The North Wales Wind Farms Connection Project

SP Manweb's Response to Submissions from
Interested Parties submitted at Deadline 5

Application Reference: EN020014

Deadline 7 Submission
3rd December 2015

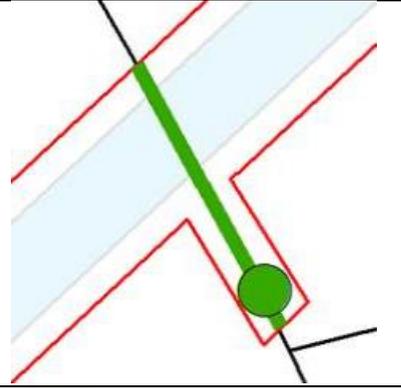
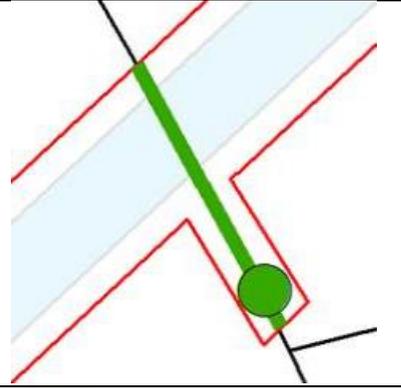
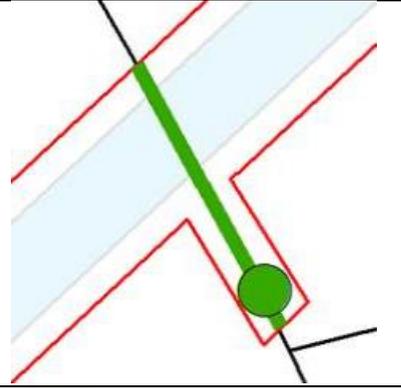
<p>Eifion Bibby on behalf of R Evans</p>	<p><u>Option B pole locations</u> Can pole 38 be moved due south and pole 39 moved more centrally within the same plot, with the addition of an H pole on</p>	<p>SP Manweb accepted this suggestion and it forms part of the Option B submission. Please see Comparison Plans Sheet 2 Document reference OPTIONB CP.2 (Examination Library reference OpB-013)</p>

Respondent	Written Representation	SP Manweb Response				
(Plot 16)	the next property boundary due north? This would, it is argued, remove the need for stays to be attached to pole 40.					
Eifion Bibby on behalf of R Evans (Plot 16)	<p><u>Enhancement and replacement planting</u></p> <p>Requests clarification on areas required permanently for proposed for enhancement and replacement planting. The recent plan forwarded from the applicant to the interested party is not sufficiently clear.</p>	<p>SP Manweb has clearly explained in its response to SWQ 8.1(a) (Examination Library reference REP6-035) when landowners can "veto" planting and when they will be consulted on planting. See also Appendix 10 to SP Manweb's Written Summary of its Oral Case put forward at the Issue Hearing Specific Hearing Day 2. The submitted Landscaping Plans illustrate hedgerows that are likely to contain trees, however, the plans were misinterpreted by some interested parties to read as a continuous line of trees. This has never been the intention, as explained at the Oral Hearings, the plans highlight the difference between a hedge with no hedgerow trees, and a hedge with some individual trees. It is SP Manweb's intention is to amend the plans as shown below. The following diagram shows how this detail is proposed to be depicted in the revised Landscaping Plans:</p> <table border="1" data-bbox="1061 930 1944 1383"> <thead> <tr> <th data-bbox="1061 930 1525 999">Original Version:</th> <th data-bbox="1525 930 1944 999">Revised Version:</th> </tr> </thead> <tbody> <tr> <td data-bbox="1061 999 1525 1383">  </td> <td data-bbox="1525 999 1944 1383">  </td> </tr> </tbody> </table>	Original Version:	Revised Version:		
Original Version:	Revised Version:

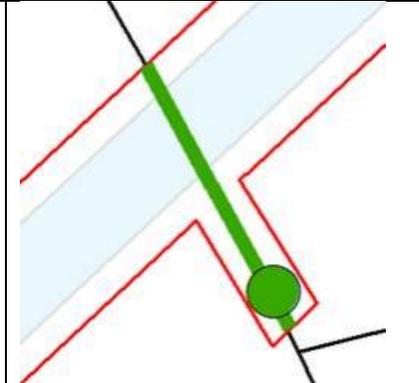
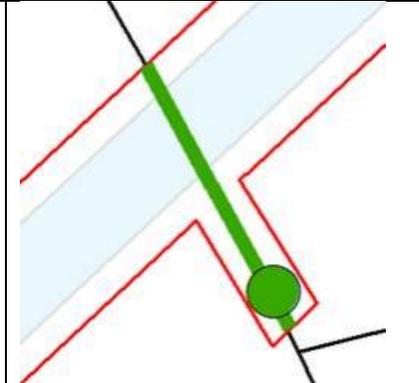
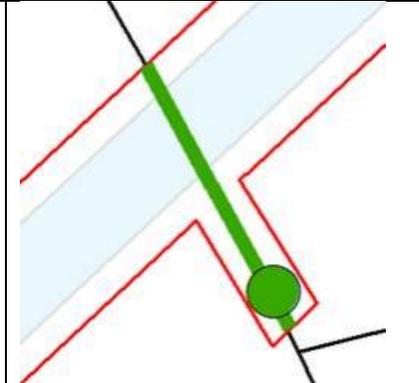
<p>Eifion Bibby on behalf of J E Davies (Plot 24)</p>	<p><u>Option B pole locations</u> Pole 59 and stays to be sited 8 metres away from the neighbouring field boundary to the south.</p>	<p>This suggestion has been accepted and is included in the Option B submission. Please see Comparison Plans Sheet 3 Document reference OPTIONB CP.3 ((Examination Library reference OpB-013).</p>
<p>Eifion Bibby on behalf of J E Davies (Plot 24)</p>	<p><u>Enhancement and replacement planting</u> Requests clarification on areas required permanently for proposed for enhancement and replacement planting. The recent plan forwarded from the applicant to the interested party is not sufficiently clear.</p>	<p>SP Manweb has clearly explained in its response to SWQ 8.1(a) (Examination Library reference REP6-035) when landowners can "veto" planting and when they will be consulted on planting. See also Appendix 10 to SP Manweb's Written Summary of its Oral Case put forward at the Issue Hearing Specific Hearing Day 2. The submitted Landscaping Plans illustrate hedgerows that are likely to contain trees, however, the plans were misinterpreted by some interested parties to read as a continuous line of trees. This has never been the intention, as explained at the Oral Hearings, the plans highlight the difference between a hedge with no hedgerow trees, and a hedge with some</p>

Respondent	Written Representation	SP Manweb Response						
		<p>individual trees. It is SP Manweb's intention is to amend the plans as shown below. The following diagram shows how this detail is proposed to be depicted in the revised Landscaping Plans:</p>

<p>These revised Landscaping Plans are being prepared for the purposes of further discussions with relevant landowners and the two local planning authorities and will be submitted as soon as they are available in January 2016.</p>	Original Version:	Revised Version:			<p>— Hedgerow Improvements: Mix 1 ●●● Hedgerows with Tree Planting Mix 1</p>	<p>— Hedgerow Improvements: Mix 1 ● Indicative Location of Individual Tree</p>
Original Version:	Revised Version:

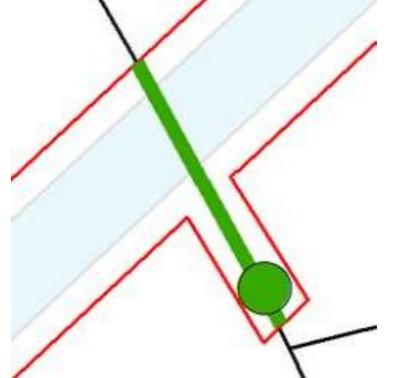
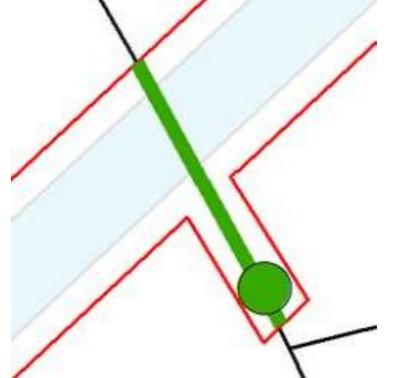
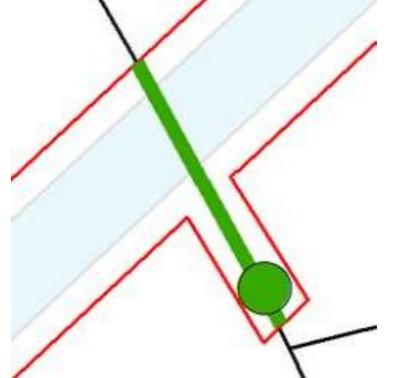
<p>Eifion Bibby on behalf of HW, EA and GH Hughes (Plots 52- 52E, 53, 56,</p>	<p><u>Option B pole locations</u> Pole 119 to be moved as far west of the adjacent boundary fence as possible</p>	<p>This suggestion has been accepted and is included in the Option B submission. Please see Comparison Plans Sheet 8 Document reference OPTIONB CP.8 (Examination Library reference OpB-014)</p>

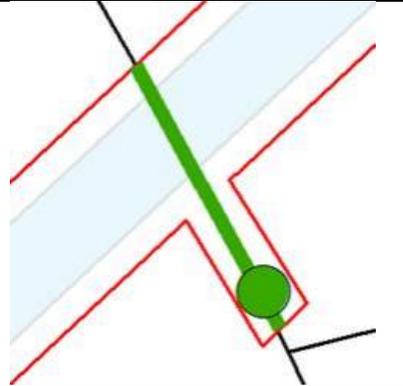
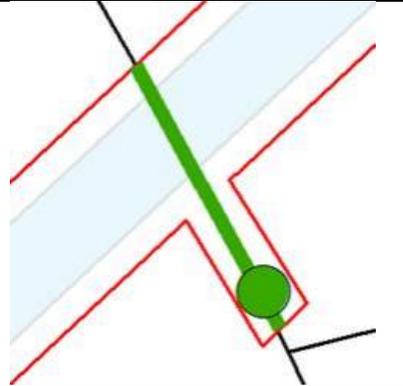
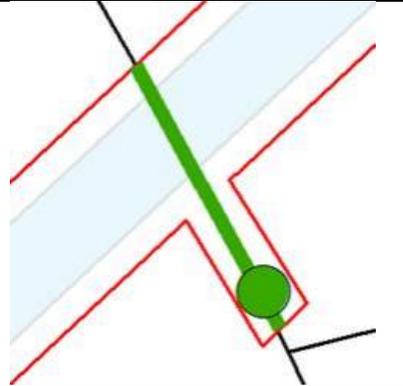
Respondent	Written Representation	SP Manweb Response						
<p>on behalf of M Jones (Plots 59 and 61)</p>	<p>Requests clarification on areas required permanently for proposed for enhancement and replacement planting. The recent plan forwarded from the applicant to the interested party is not sufficiently clear.</p>	<p>Library reference REP6-035) when landowners can "veto" planting and when they will be consulted on planting. See also Appendix 10 to SP Manweb's Written Summary of its Oral Case put forward at the Issue Hearing Specific Hearing Day 2. The submitted Landscaping Plans illustrate hedgerows that are likely to contain trees, however, the plans were misinterpreted by some interested parties to read as a continuous line of trees. This has never been the intention, as explained at the Oral Hearings, the plans highlight the difference between a hedge with no hedgerow trees, and a hedge with some individual trees. It is SP Manweb's intention is to amend the plans as shown below. The following diagram shows how this detail is proposed to be depicted in the revised Landscaping Plans:</p>

Original Version:	Revised Version:			<p>— Hedgerow Improvements: Mix 1</p> <p>●●●● Hedgerows with Tree Planting Mix 1</p>	<p>— Hedgerow Improvements: Mix 1</p> <p>● Indicative Location of Individual Tree</p>
Original Version:	Revised Version:

Respondent	Written Representation	SP Manweb Response
		<p>These revised Landscaping Plans are being prepared for the purposes of further discussions with relevant landowners and the two local planning authorities and will be submitted as soon as they are available in January 2016.</p>
<p>Eifion Bibby on behalf of M Jones (Plots 59 and 61)</p>	<p>Plan entitled: "Draft Indicative Pole Positions within the limit of deviation including enhancement and replacement planting details for information purposes"</p>	
	<p>Mr Bibby considers that the areas delineated on the above plan and the Land Plans in respect of which temporary and permanent rights are sought are inconsistent and ambiguous.. Mr Bibby requests the applicant to produce one plan which illustrates both.</p>	<p>SP Manweb has clearly explained in its response to SWQ 12.4, that all "Class 2" rights relating to construction of the 132kV Overhead Line and the compound and "Class 4" rights relating to tree felling have been removed. For construction, SP Manweb will only rely on temporary use powers in Article 27 of the draft DCO, which is not a compulsory acquisition power. All other rights (i.e. over the blue land and the green land) are required for the duration of the 132kV Overhead Line. It is considered that the Land Plans (Examination Library reference REP6-032 and REP6-033) demonstrate this position clearly.</p>

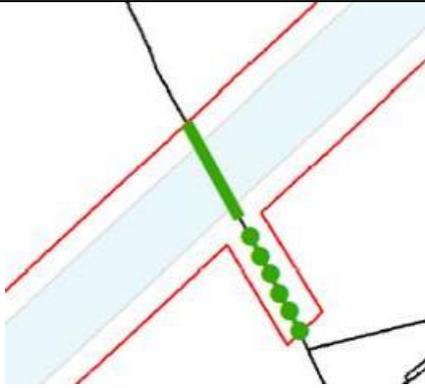
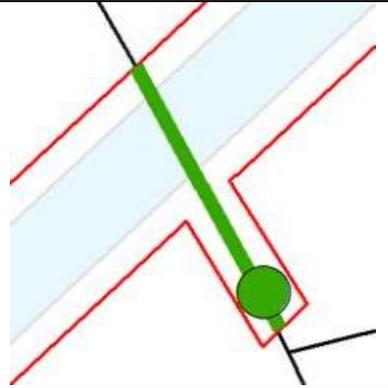
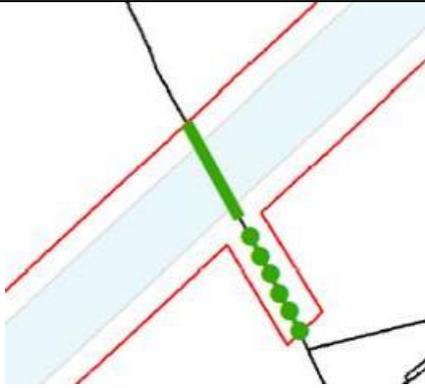
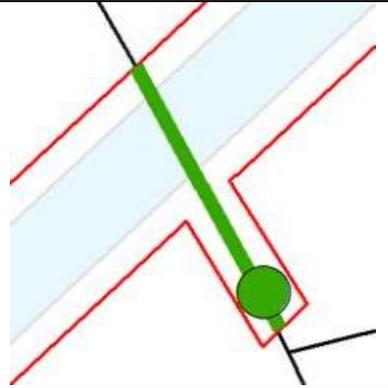
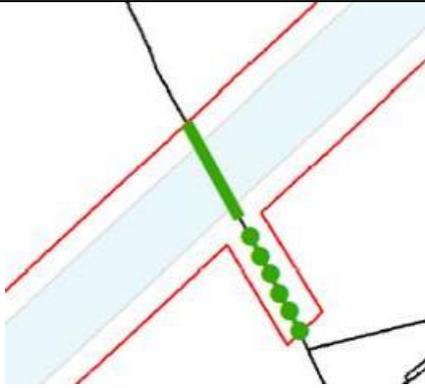
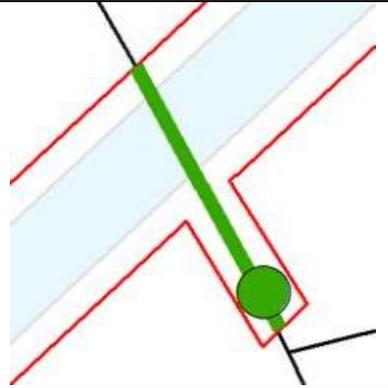
<p>Eifion Bibby on behalf of AA Owen (Plots 94 and</p>	<p><u>Enhancement and replacement planting</u> Requests clarification on areas required permanently for proposed for enhancement and replacement planting. The recent plan</p>	<p>SP Manweb has clearly explained in its response to SWQ 8.1(a) (Examination Library reference REP6-035) when landowners can "veto" planting and when they will be consulted on planting. See also Appendix 10 to SP Manweb's Written Summary of its Oral Case put forward at the Issue</p>

Respondent	Written Representation	SP Manweb Response						
98)	forwarded from the applicant to the interested party is not sufficiently clear.	<p>Hearing Specific Hearing Day 2. The submitted Landscaping Plans illustrate hedgerows that are likely to contain trees, however, the plans were misinterpreted by some interested parties to read as a continuous line of trees. This has never been the intention, as explained at the Oral Hearings, the plans highlight the difference between a hedge with no hedgerow trees, and a hedge with some individual trees. It is SP Manweb's intention is to amend the plans as shown below. The following diagram shows how this detail is proposed to be depicted in the revised Landscaping Plans:</p>

<p>These revised Landscaping Plans are being prepared for the purposes of further discussions with relevant landowners and the two local planning authorities and will be submitted as soon as they are available in January</p>	Original Version:	Revised Version:			<ul style="list-style-type: none"> — Hedgerow Improvements: Mix 1 ●●●● Hedgerows with Tree Planting Mix 1 	<ul style="list-style-type: none"> — Hedgerow Improvements: Mix 1 ● Indicative Location of Individual Tree
Original Version:	Revised Version:
